Service Bulletin FSN-30

Subject: NC-300 Changes

Service Bulletin FSN-32

# NC-300 REVISIONS

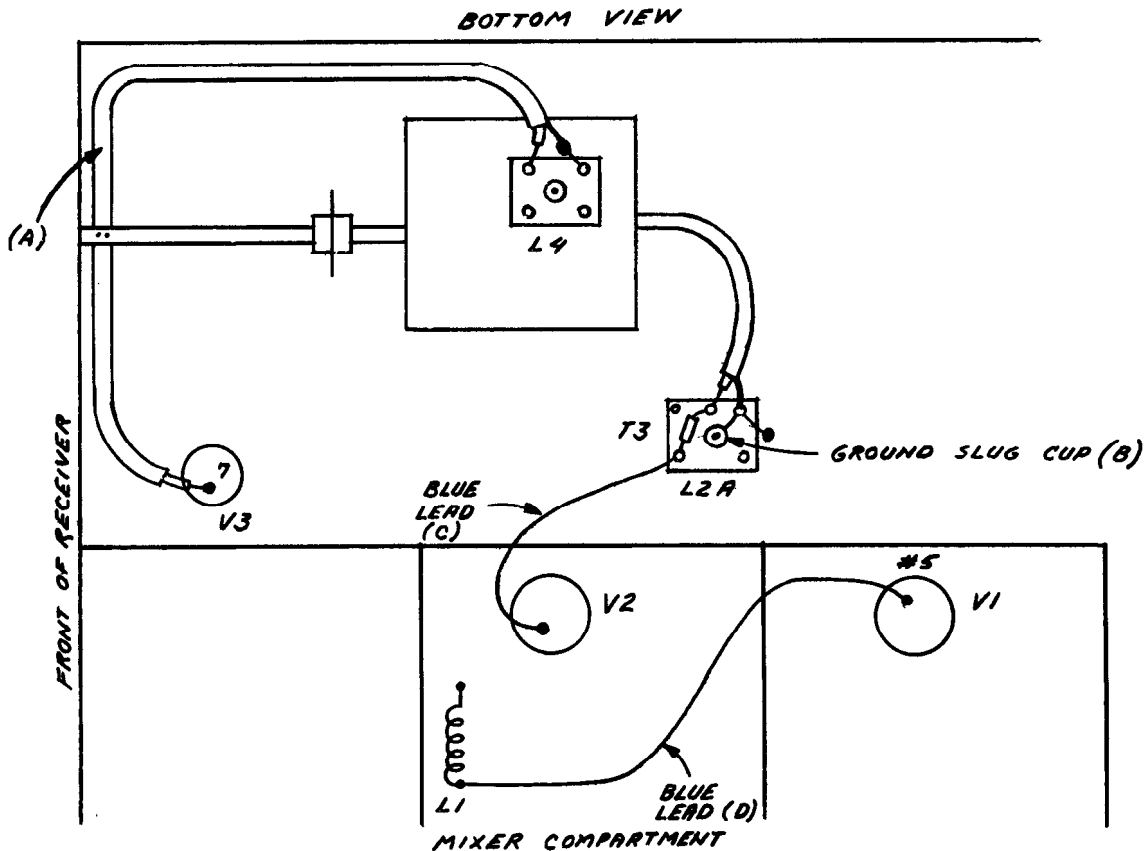
A shielded lead should be constructed as shown below:

- A. Replace shielded lead from L4 to grid of second converter, V3 with above lead, placing it under phasing control shaft as shown in the pictorial diagram below.

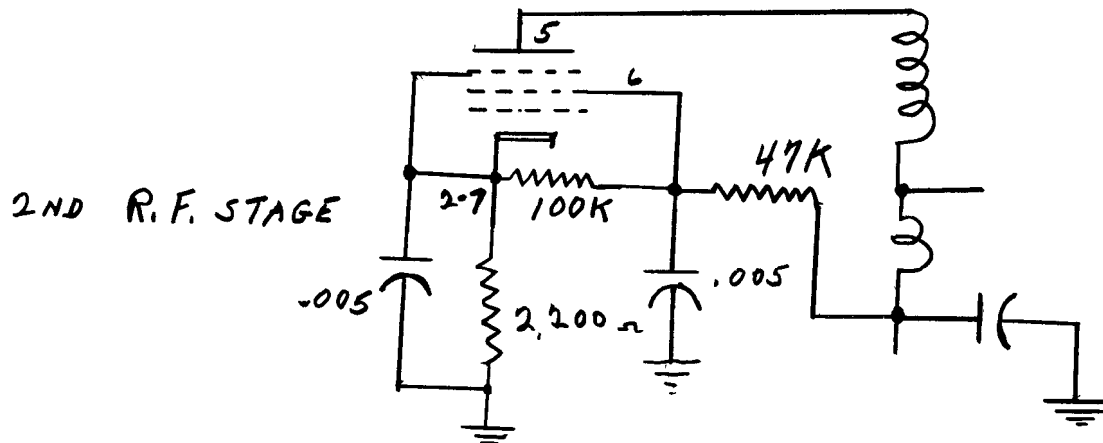
The following changes are recommended in the 6-meter converter to reduce cross-modulation:

Change cathode resistor in 6AK5 2nd R.F. amplifier stage from 470 ohms  $\frac{1}{2}$  watt to 2200 ohms  $\frac{1}{2}$  watt

A 100,000 ohm  $\frac{1}{2}$  watt resistor should be connected between Pin #6 and Pin #2 - 7 of the same 6AK5 2nd R.F. stage

Revised circuit below:

Bulletin Number FSN-48

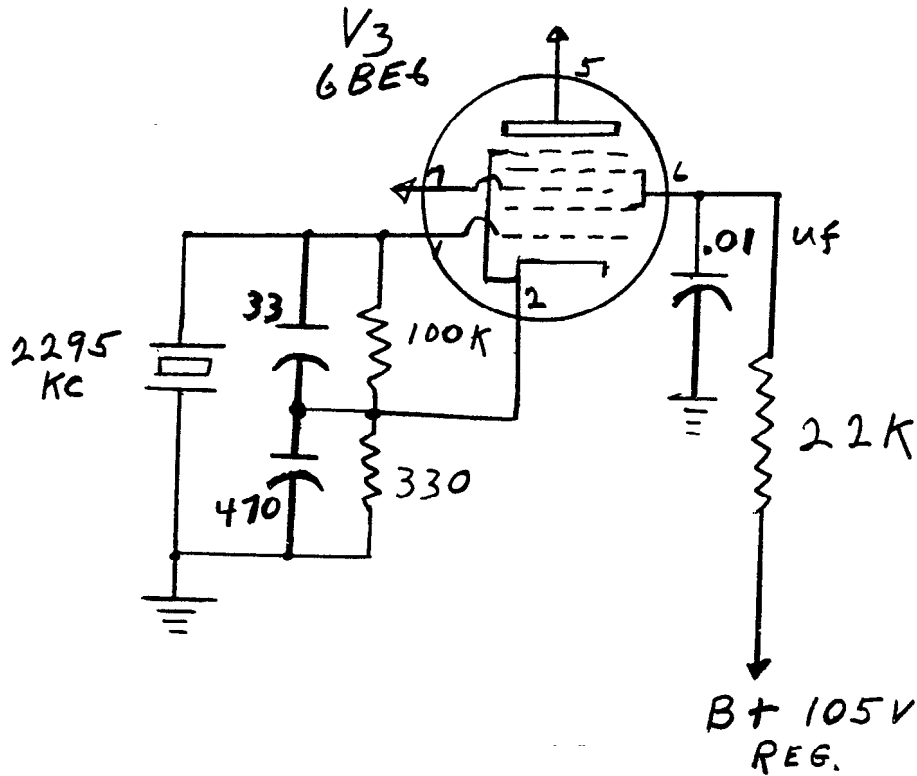
In these instances we recommend crystal control of the second conversion oscillator as per the attached schematic. It should be remembered that there are now two crystals in the circuit which must be properly coordinated if the receiver is to work at maximum efficiency. Normal production tolerances in the grinding of the crystals may allow a situation to exist where the difference in frequency of the crystal in the crystal filter (2215 kc) and the crystal in the second conversion oscillator (2295 kc) is not exactly 80 kc (second IF).

Fig. 1—Crystal controlled second converter.

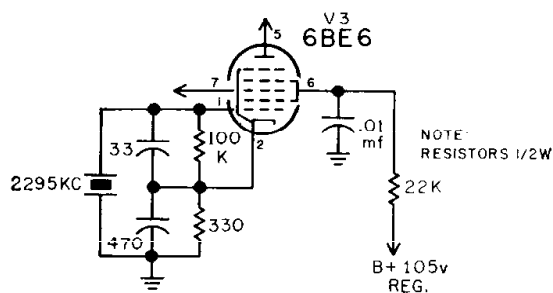
It is a simple matter to crystal control the second converter oscillator which effectively eliminates these problems.

The crystal and its associated components may be mounted in the shield can which formerly housed L6 the second conversion oscillator coil.

Fig. 2—Two new components improves audio.

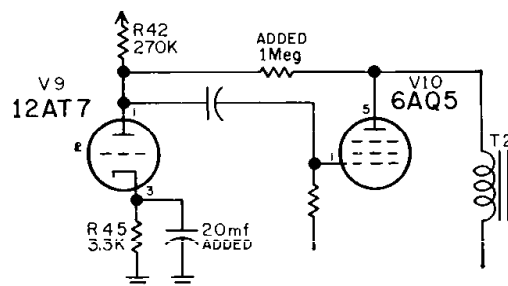
An audio change that will improve the phone quality is shown in fig. 2. It consists of a 1 megohm resistor connected between the plate of the output tube and the plate of the preceding audio stage. This has a tendency to drop the audio level which can be restored by bypassing the cathode of V9, R45 with a 20 mf. 50 volt capacitor to chassis ground.
